CERTIFICATE OF APPROPRIATENESS

Property: 540 Columbia Street, Lot 22, Block 286, Houston Heights Subdivision. The property includes a historic 1,840 square foot, one-story wood frame single-family residence and a detached garage situated on a 6,600 square foot (50' x 132') interior lot.

Proposal: Alteration/Relocation – Move house 8' closer to the north property line, from current 10'-9" setback to 3'. Construct a 1,553 square foot addition and attached garage behind and on top of the rear 27.5% of the 1,840 square foot residence. The project will also include the following alterations:

Recommendation: Denial - does not satisfy criteria 1, 4, 8 & 9

NORTH SIDE ELEVATION

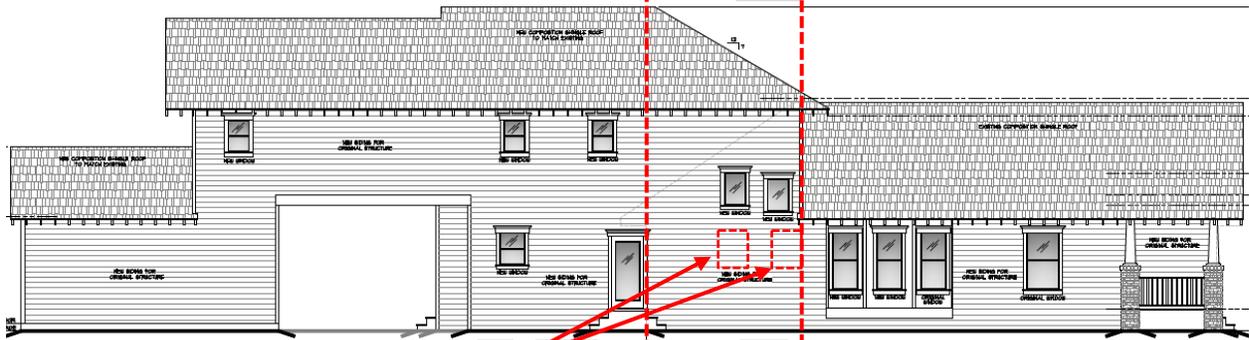
| <input type="checkbox"/> | <input checked="" type="checkbox"/> | <input type="checkbox"/> | (4) The proposed activity must preserve the distinguishing qualities or character of the building, structure, object or site and its environment; <i>By beginning the second floor of the addition on top of the residence, 14'-7" forward of the original rear wall, and extending both side walls back on the first floor with no delineation between the original house and the addition, this proposal muddles the original form of the residence. In addition, moving the house from 10'-9" to 3' of the north property line eliminates the historic context of the residence which is currently centered on the lot.</i> |
| <input type="checkbox"/> | <input checked="" type="checkbox"/> | <input type="checkbox"/> | (9) The proposed design for any exterior alterations or addition must not destroy significant historical, architectural or cultural material and must be compatible with the size, scale, material and character of the property and the area in which it is located; <i>Constructing the addition on top of the rear 27.5% of the original house requires rebuilding the original walls below to support the additional weight and visually overwhelms the original house. The removal of three original wood windows and re-arrangement of window openings permanently</i> |

removes significant historic material.

SITE PLAN

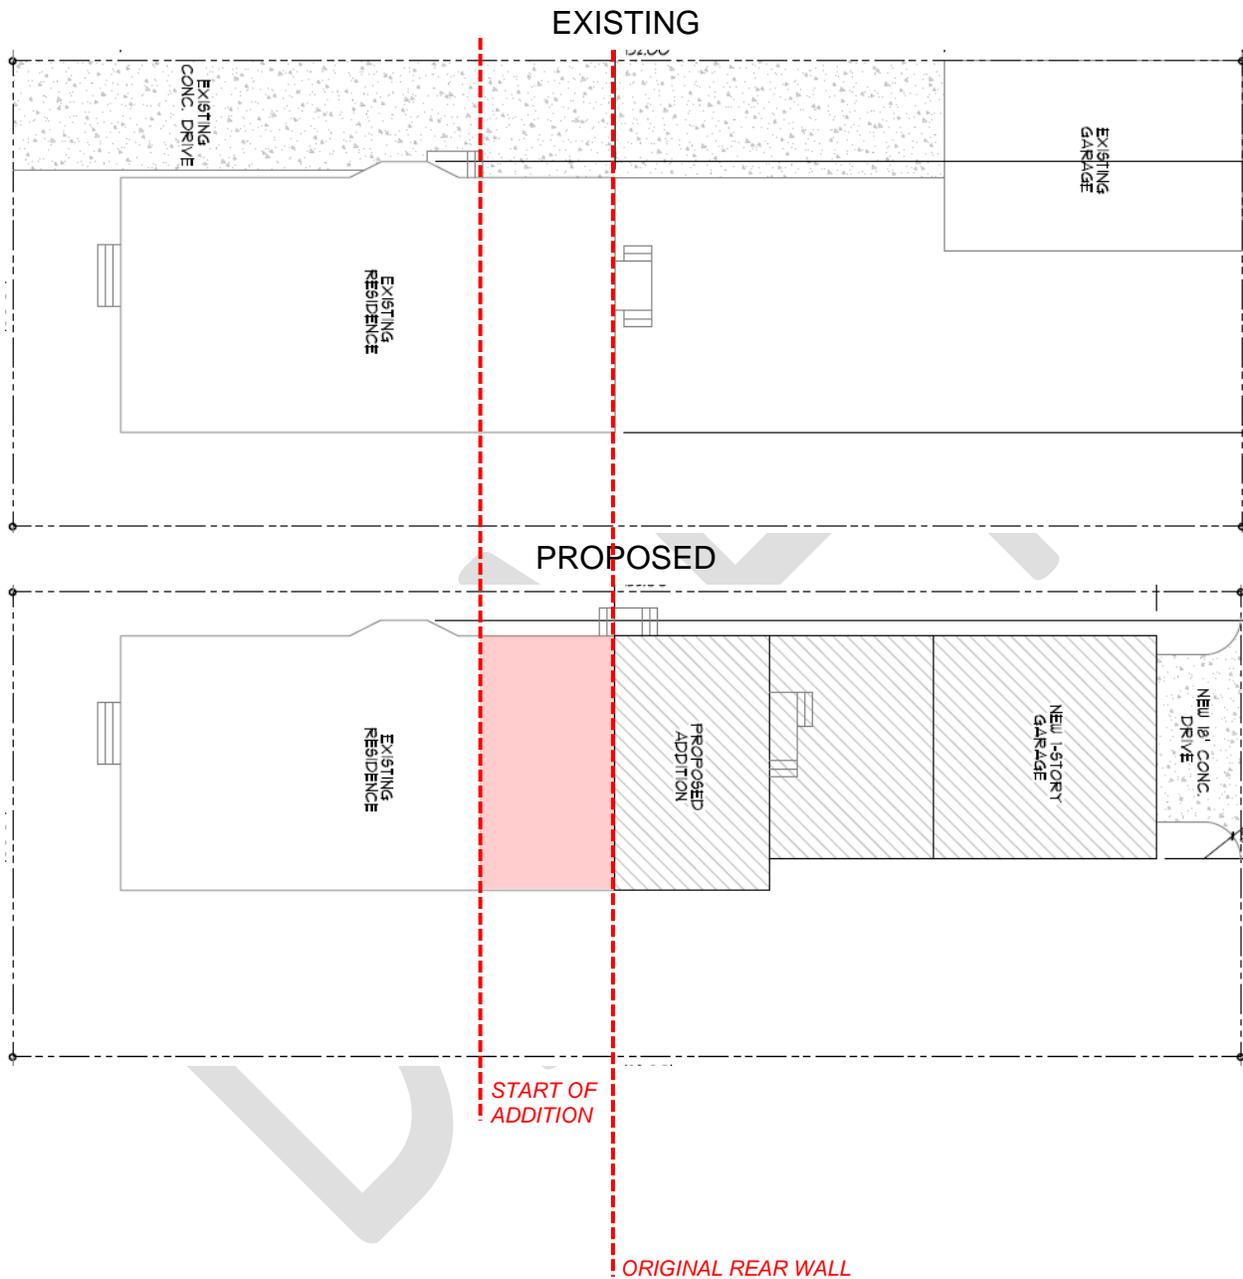
| | <input checked="" type="checkbox"/> | <input type="checkbox"/> | (1) The proposed activity must retain and preserve the historical character of the property; <i>Although the project involves many positive alterations to return the house to a more appropriate historic character, beginning the second floor of the addition on top of the residence, 14'-7" forward of the original rear wall, and extending both side walls back on the first floor with no delineation between the original house and the addition, muddles the original form of the residence and damages its historic character. In addition, moving the house from 10'-9" to 3' of the north property line eliminates the historic context of the residence, which is currently centered on the lot. The current lot configuration is typical for the Heights, and should be preserved.</i> |

EXISTING WINDOWS AND SIDING

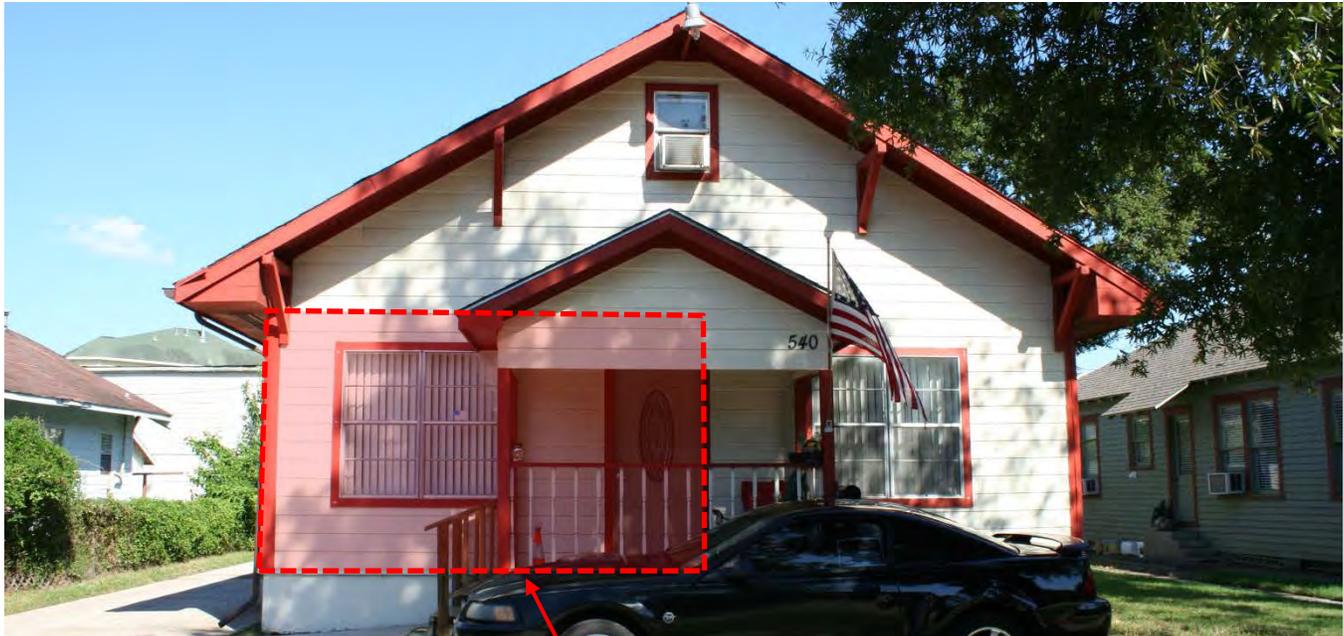
*ORIGINAL WINDOWS TO BE REMOVED
(SEE DETAIL BELOW)*
